69 Avenue Road
London
NW8 6HP

Basement Impact Assessment
Audit

For
London Borough of Camden

Project Number: 13398-39
Revision: F1

Figure 5 - GOV.UK Low Occurrence Risk of Flooding from Surface Water

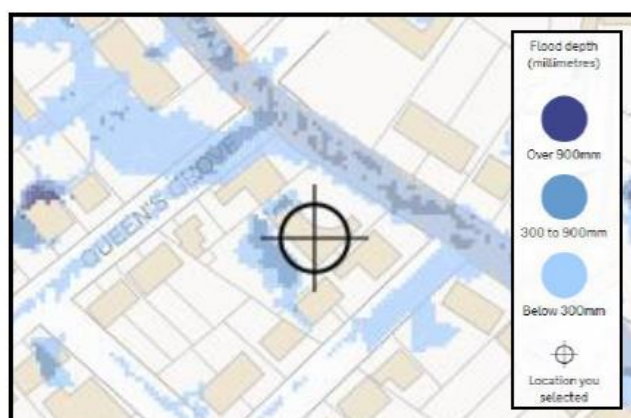
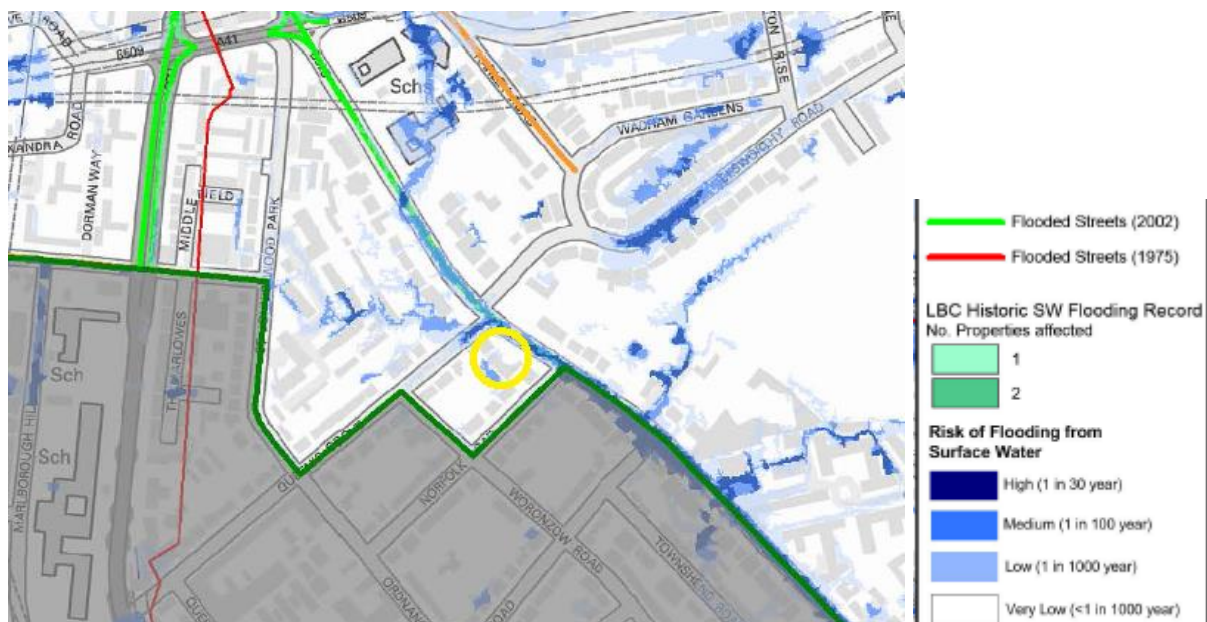
The site is on a previously flooded street (2002 major flood incident) and therefore is designated locally as an area of higher flood risk under the Local Plan (policy CC3). See extract below from Camden's Strategic Flood Risk Assessment.

Figure 5 from the report gives an approximate indication of the modelled extents and locations of surface water flooding at or around the site.

In addition section 5.22 of the Surface Water Flow and Flood Risk Assessment identifies that the site as being located within close proximity to the original route of a tributary of the River Tyburn and that overland flow may still be following the original course. Overland flow is shown to drain along Avenue Road.
